Note in Response to Applicant ES Addendum (February 2022) – Matters relating to the Water Environment

Appeal APP/U2235/C/08/2087987 by Mr Guy Harrison, Monk Lakes,
Staplehurst Road, Marden, TN12 9BS against Enforcement Notice
issued 12 September 2008

Site address	Hertsfield Barn, Marden, Kent, TN12 9BW
Report prepared for	David Padden The Rear Barn, The Manor Farm 124 Manor Road North, Thames Ditton Surrey, KT7 0BH
Report reference	70276R4
Report status	DRAFT
Date issued	13 April 2022
Report author	Dr Paul Ellis BSc, PhD, C. Geol

Figure 1 Environment Agency Risk of flooding from Rivers and Sea (ROFRAS)

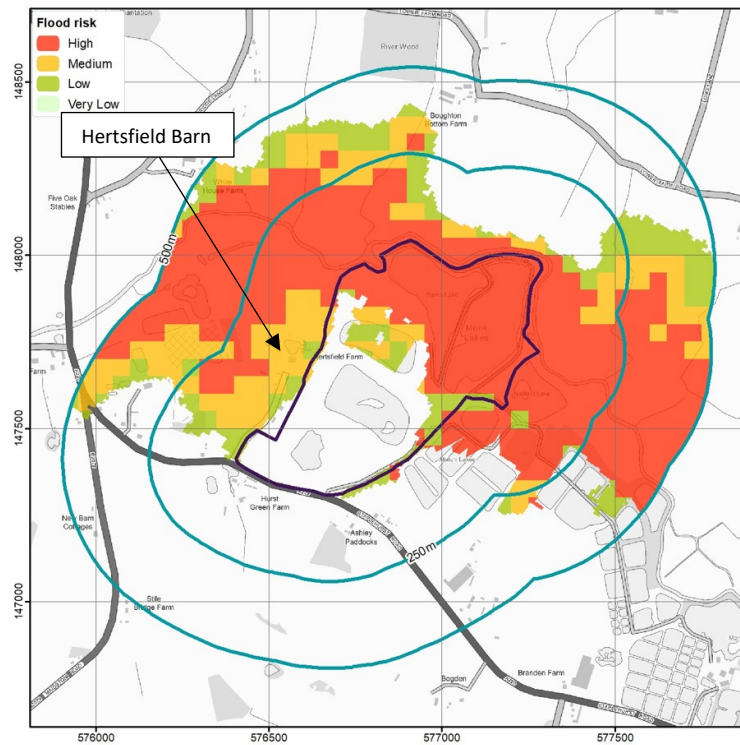
Fluvial flooding is acknowledged as a risk, and will require the implementation of a flood storage compensation scheme to mitigate the impact on other receptors. We note that parts of the site currently designated at Low risk in Flood Zone 1, are likely to have been at a lower elevation (and therefore at higher risk) under baseline (pre-development) conditions. It is evident from the data in Figure 1, the Environment Agency model used to define the flood zones is using the recent topography after land raising has occurred.

Figure 2 Susceptibility to groundwater flooding map, version 6.1, British Geological Survey.

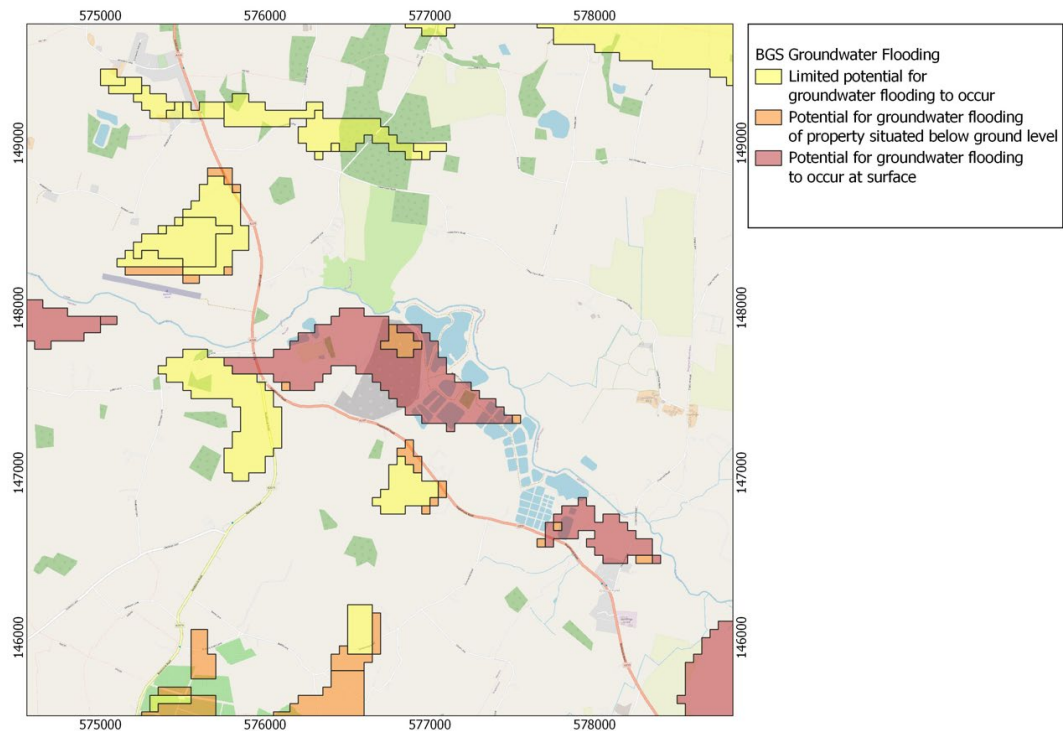
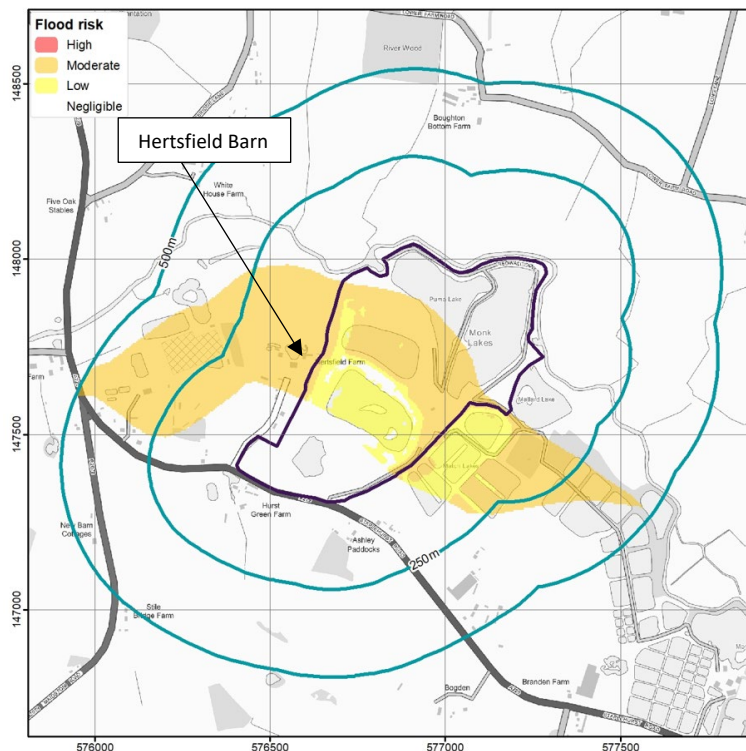
Two commercially available, national data sets identify both Monk Lakes and Hertsfield Barn to be at risk of groundwater flooding. This is likely as a result of the shallow groundwater table within the permeable superficial deposits. As indicated in

our previous statements there is evidence to suggest that the development has increased the risk of groundwater flooding.

- 4.9. Groundwater flooding is not considered a significant risk by the appellant, despite the published data to the contrary presented in Figures 2 and 3, and the long history at the site surrounding the investigation of groundwater flooding, including a previous judicial review. The applicant's boreholes have proved the existence of a shallow groundwater table and BGS mapping supported by site investigation data from Mr Padden indicates the aquifer extends beneath Hertsfield Barn. As discussed in our previous report (Geosmart, 2019a) groundwater contours indicate potential groundwater flow from Monk Lakes, towards Hertsfield Barn.

Figure 4 Environment Agency Surface Water flood depths for the 1 in 1000 year event.

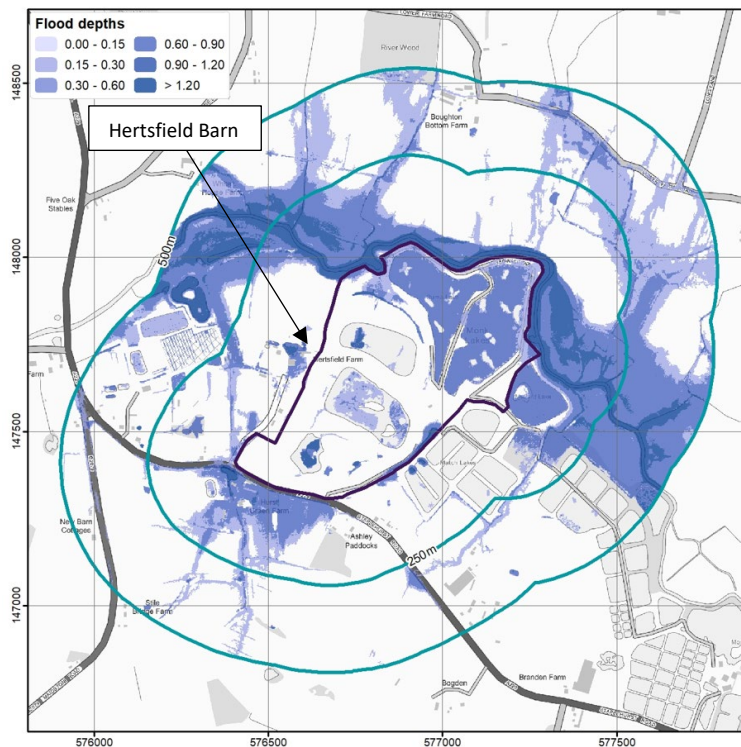
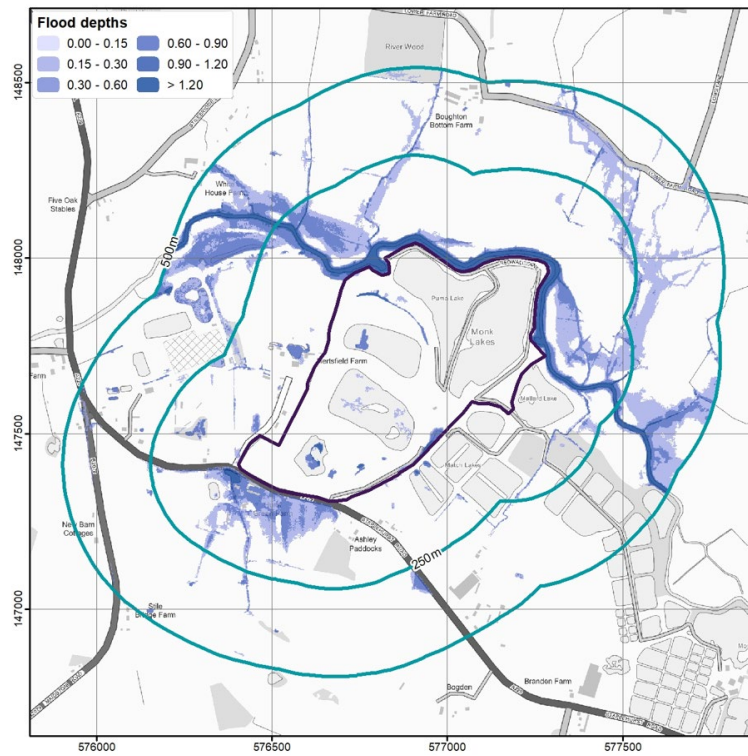
Information on the pluvial (surface water) flood depth is presented showing the extreme (1 in 1000, 0.1% AEP) and medium risk (1 in 100, 1% AEP) scenarios. The extreme case has a low probability of occurring, but highlights the risk areas around Hertsfeld Barn and the A229 to the south. The risk of surface water flooding is likely to be increased along the western margin of the development due to the presence of a steep slope and the low permeability of the material used to create the raised lake. The cumulative impact of the development on the existing off-site, surface water flood risk should therefore be considered within the impact assessment.

Figure 6 Environment Agency Maximum extent of flooding from reservoirs.

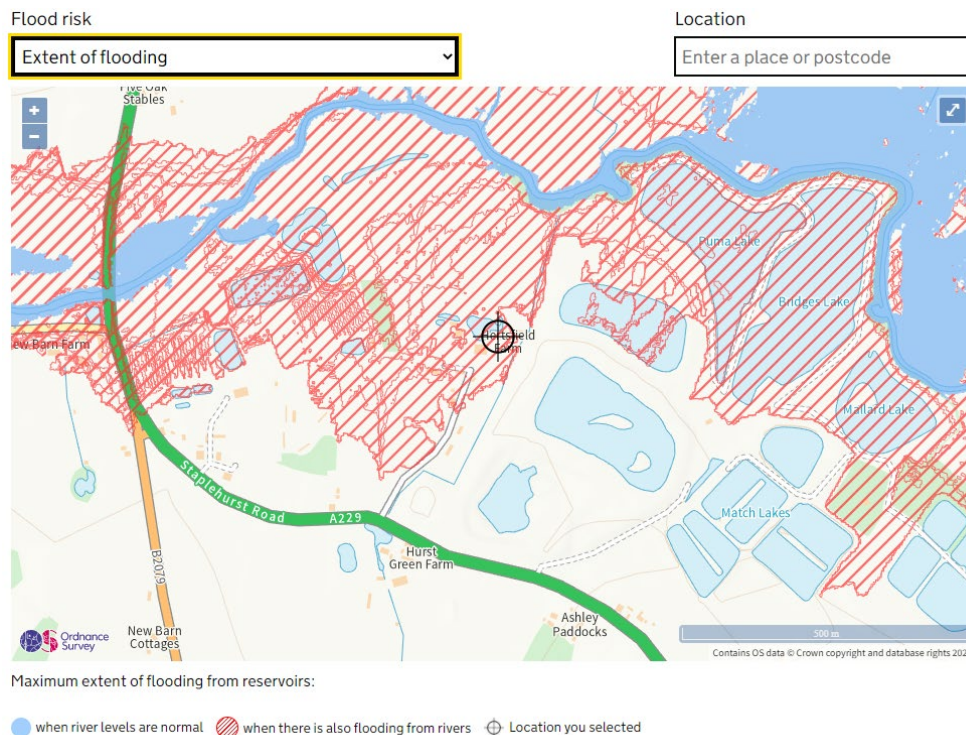
As indicated in Figure 6 Hertsfield Barn lies within the extent of reservoir flooding when there is also flooding from rivers. There will be additional cumulative risk from the adjacent raised reservoir which should be included within the impact assessment. There will remain a residual risk for as long as the raised fishing lakes are in operation, and the degree of risk will depend on the ongoing inspection and maintenance of the lake banks. To provide context, Figure 7 is a photograph taken from a drone showing the close proximity of Hertsfield Barn to the raised lakes.

- 4.14. Flooding from infrastructure failure: the applicant has indicated that, 'the Site is not reliant of any offsite infrastructure and is therefore not considered to be at risk'. However, as indicated in Figure 6 the site is identified as at risk from off-site reservoirs. The applicant also states that 'a detailed assessment of potential breach scenario of the lakes has been undertaken and shown that risk of inundation due to a breach is considered very low as the impoundment features will be managed under the Reservoirs Act 1975'. The potential magnitude of the impact on Hertsfield Barn resulting from a breach in the lakes could be very significant, despite the probability of the breach occurring being low. The reference to a breach analyses undertaken by N.Reilly in 2012, predates the final construction and filling of Lake 2 and relies upon appropriate construction methods being employed.
